# PRELIMINARY INFORMATION SHEET

PROJECT NAME: BENNINGTON  
 PROJECT NUMBER: ER BHF 010-1(45)  
 FILE NAME: z11b326\_pl.xls PLOT DATE: 8/21/2012  
 PROJECT LEADER: DEG DRAWN BY: KJK  
 DESIGNED BY: BTH CHECKED BY: SAW  
 PRELIMINARY INFORMATION SHEET SHEET 2 OF 40

THIS PROJECT INVOLVES THE RETROFITTING OF THE VERMONT ROUTE 9 BRIDGE 9 PIER FOUNDATIONS WITH MICROPILES IN THE TOWN OF BENNINGTON. THIS PROJECT DOES NOT INCLUDE ANY BRIDGE OR ROADWAY PAVEMENT REHABILITATION. THIS PROJECT WILL INVOLVE THE CONSTRUCTION OF TWO TEMPORARY ACCESS ROADS FROM VERMONT ROUTE 9 TO EITHER BRIDGE PIER.

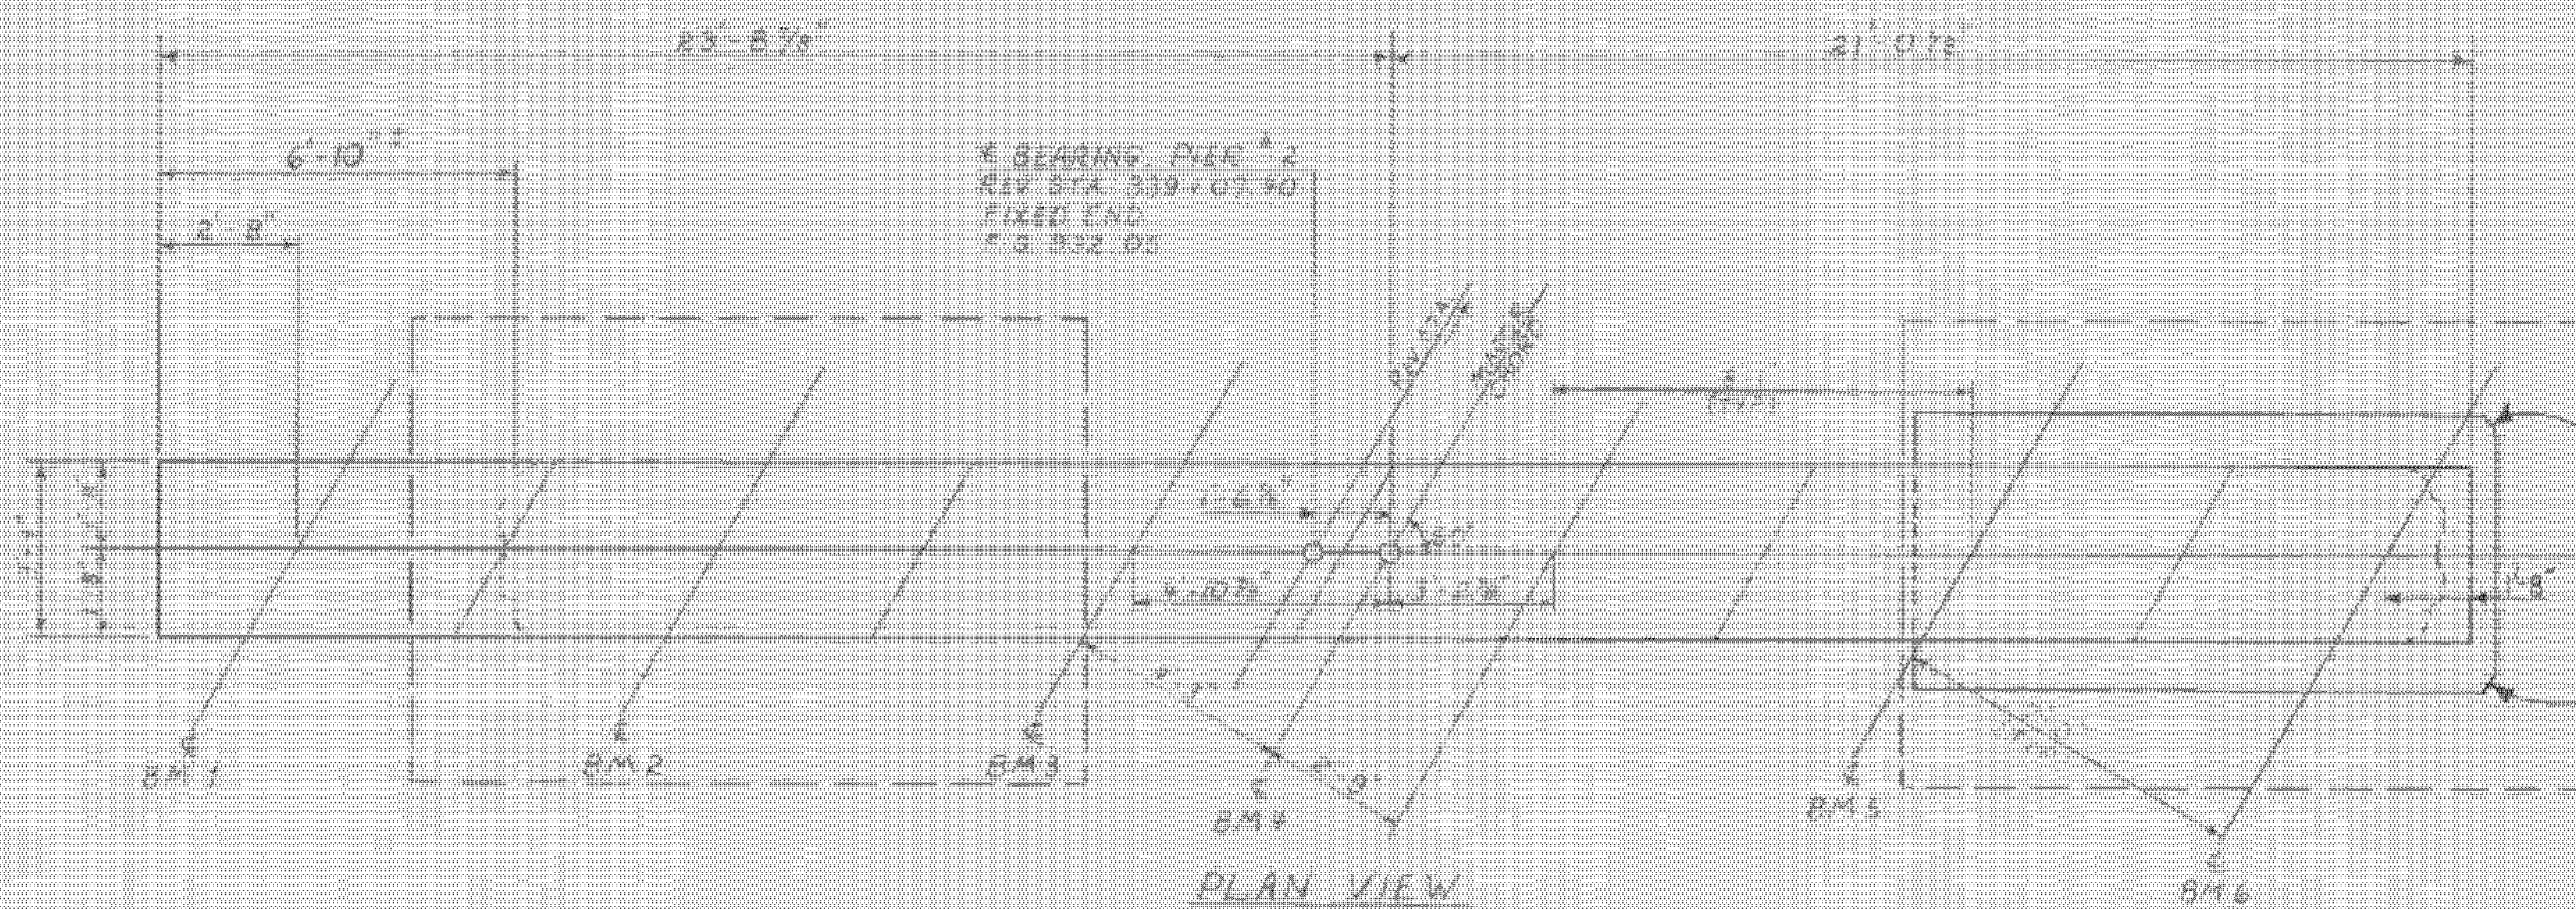
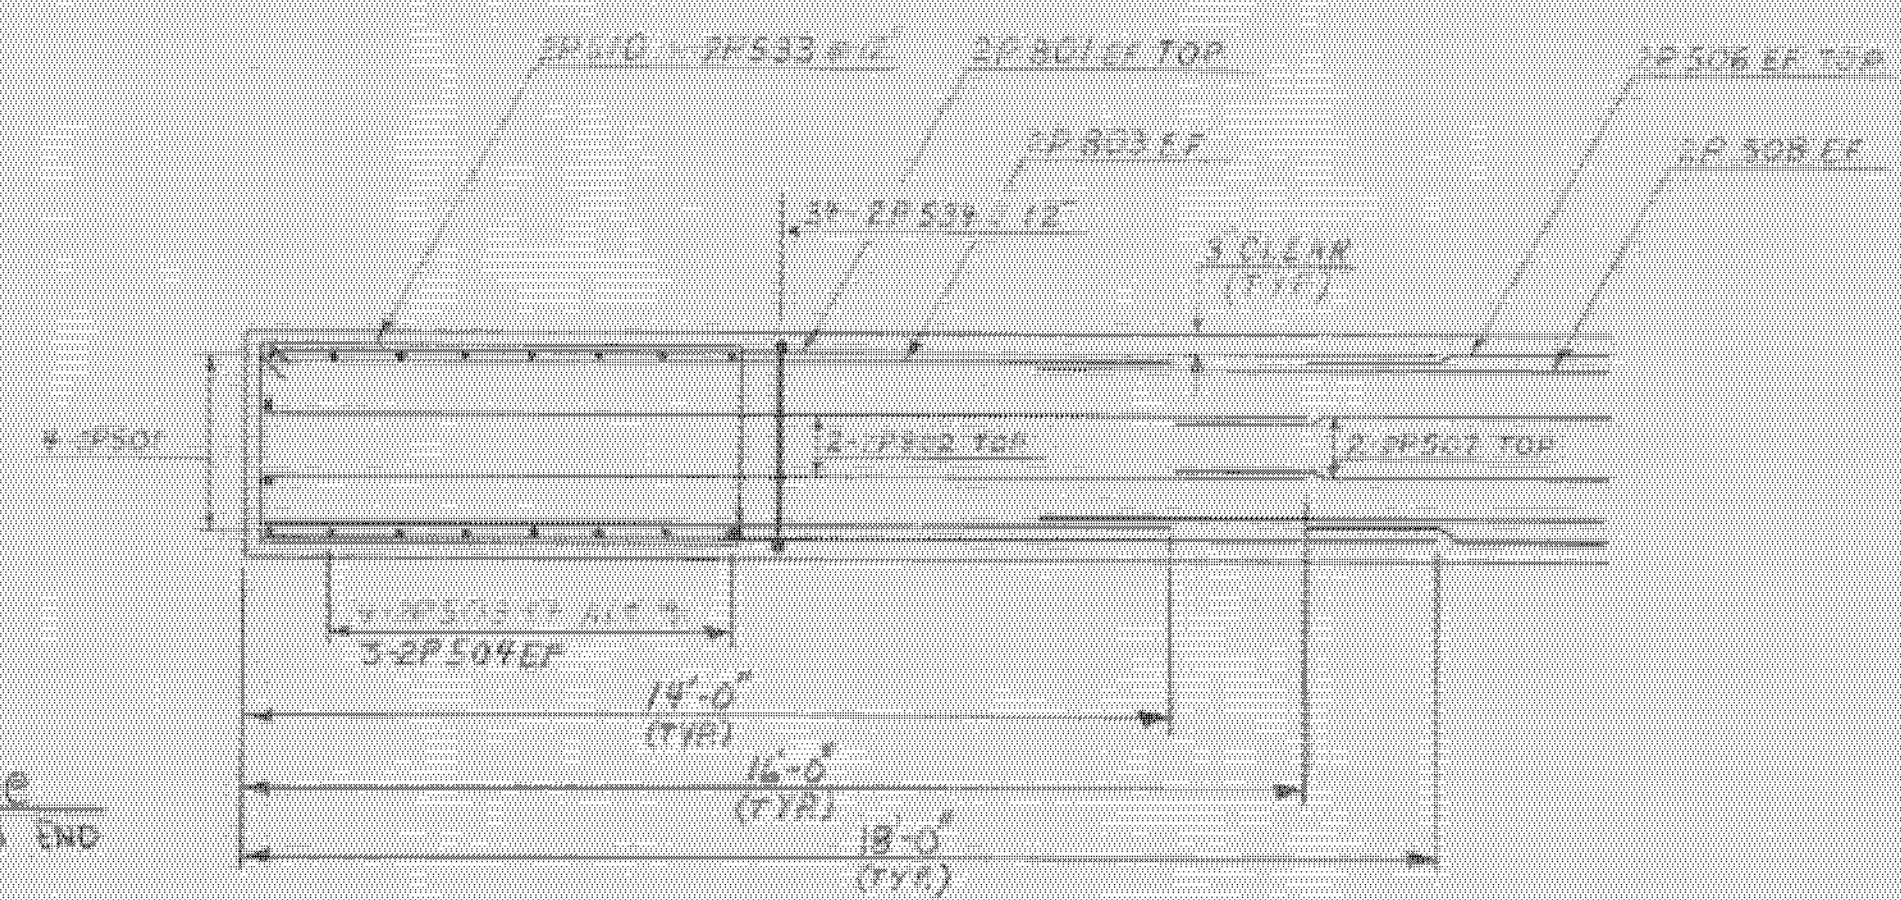
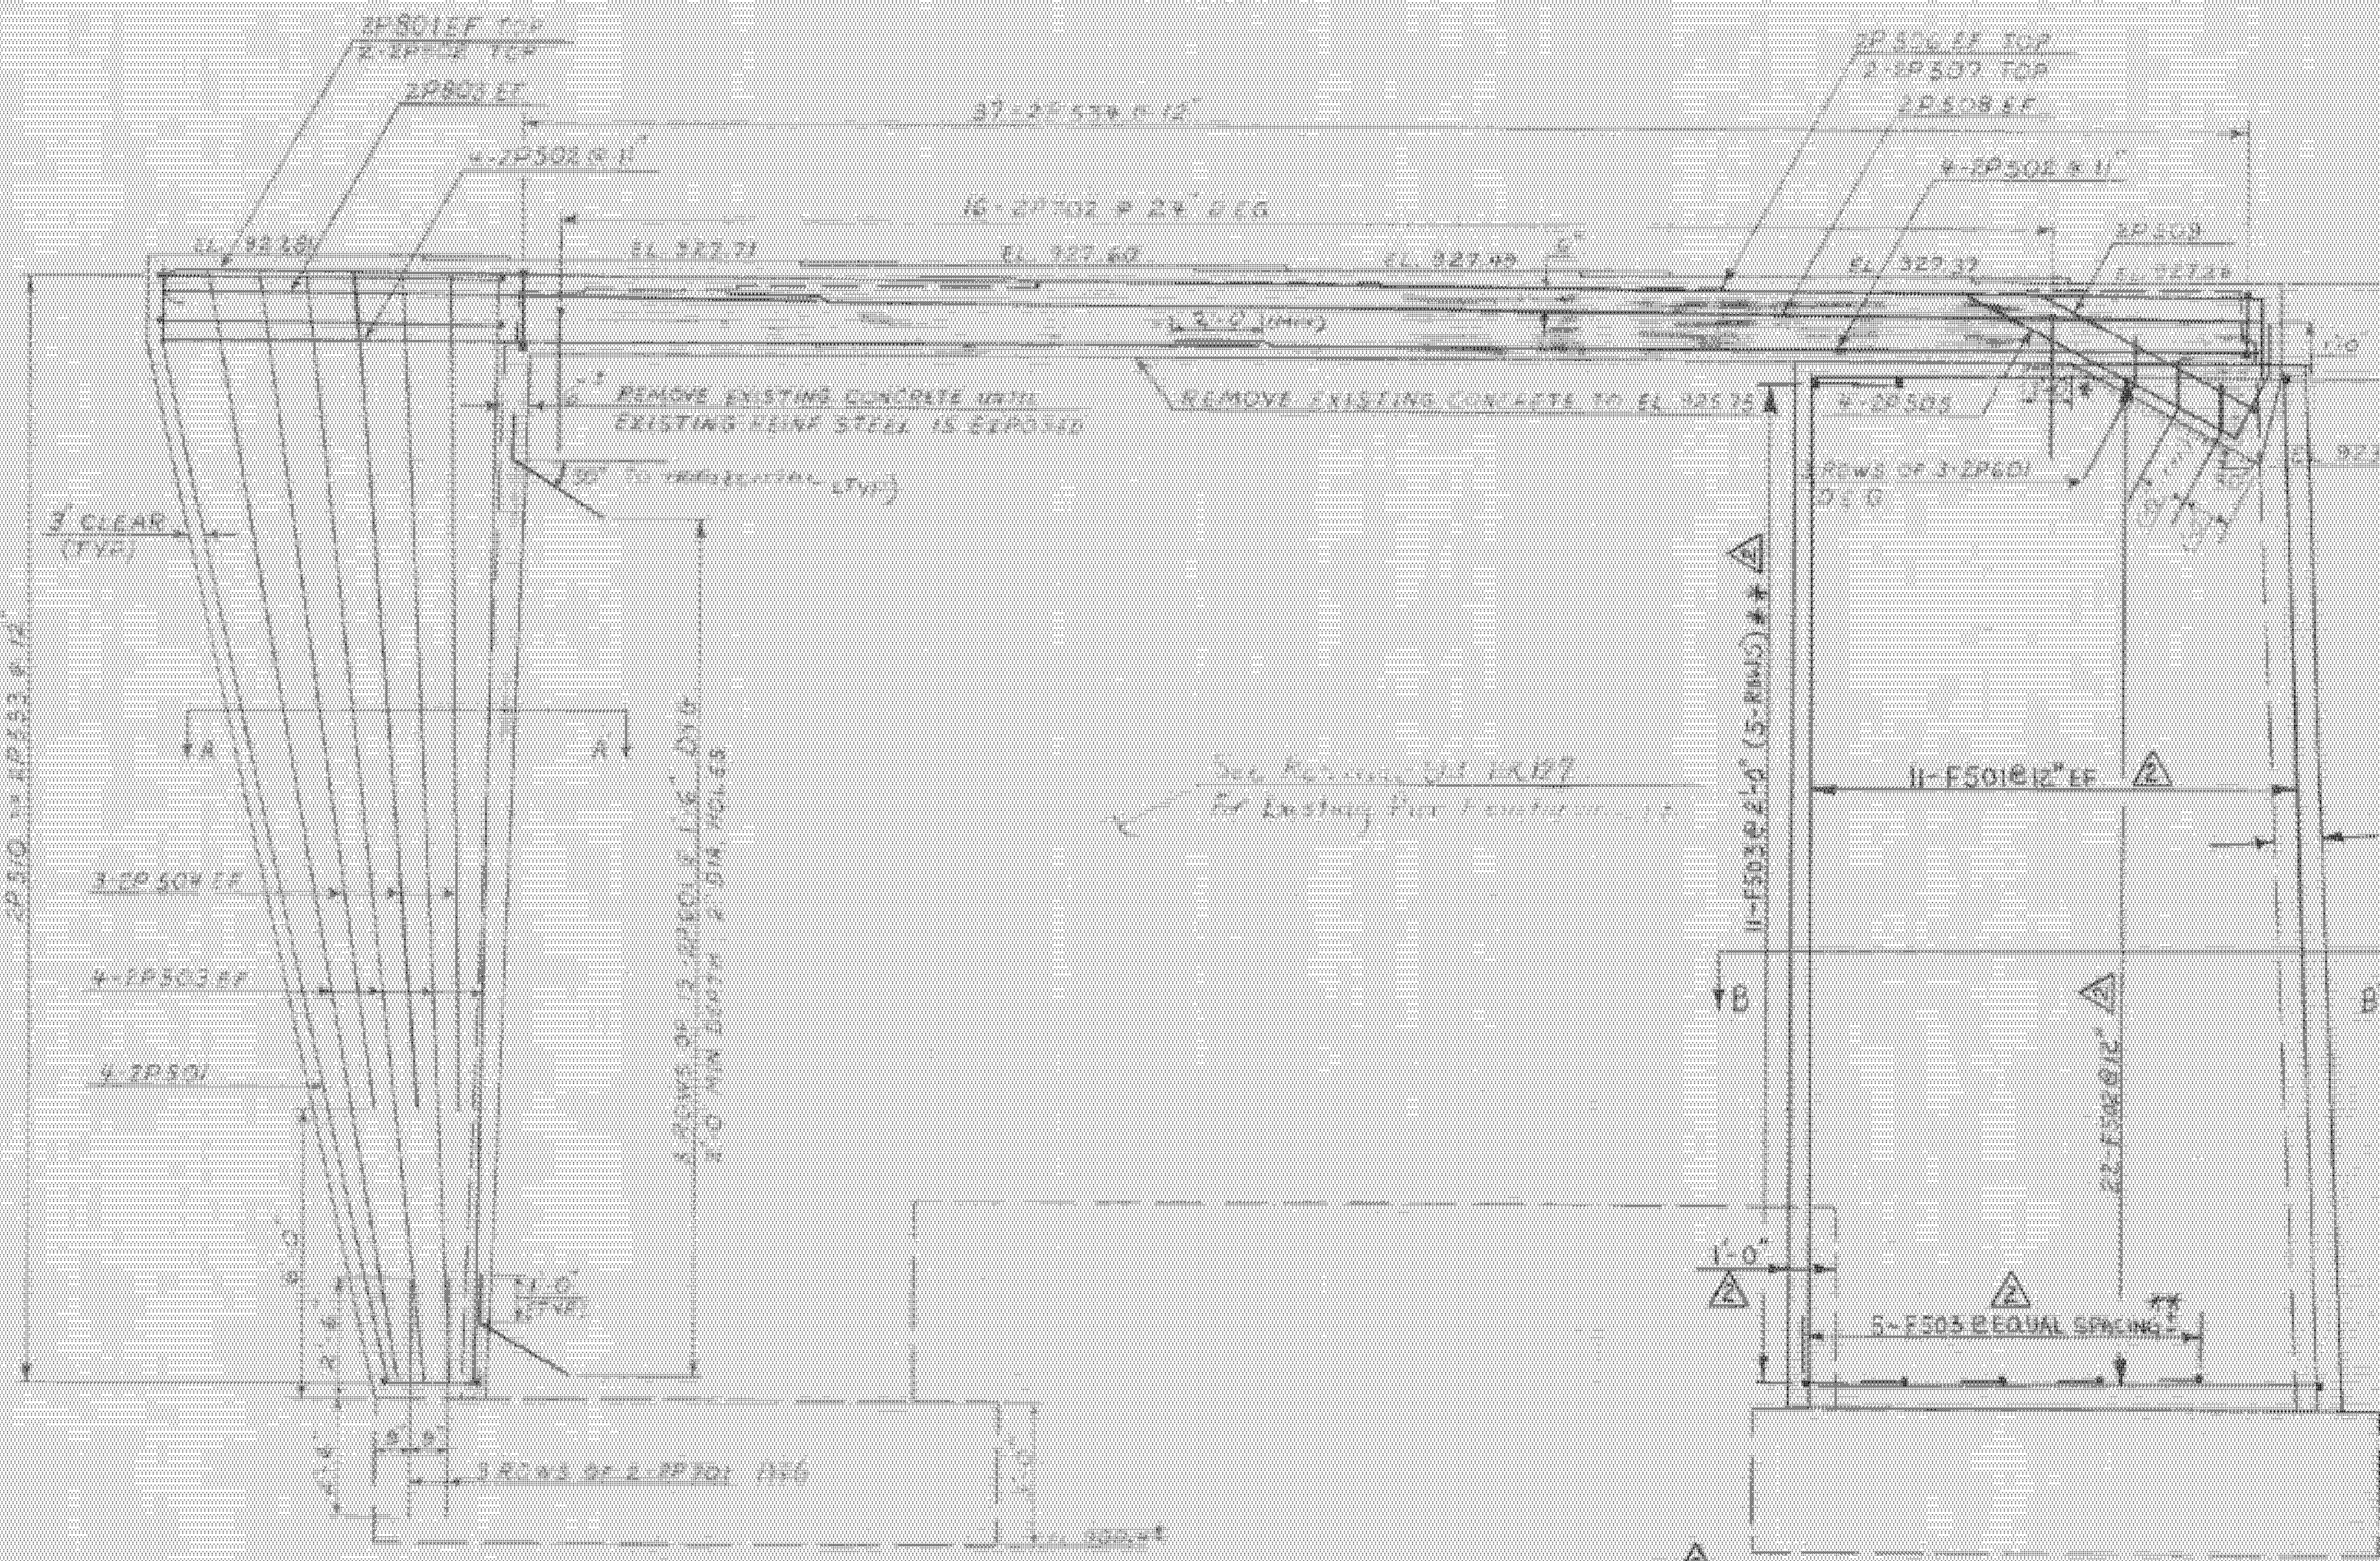
REVISED SHEET  
S. FARNSWORTH 5/88  
REVISION #2 -  
FACE THE UPSTREAM  
END OF PIER #2 WITH  
CONCRETE CLASS B.
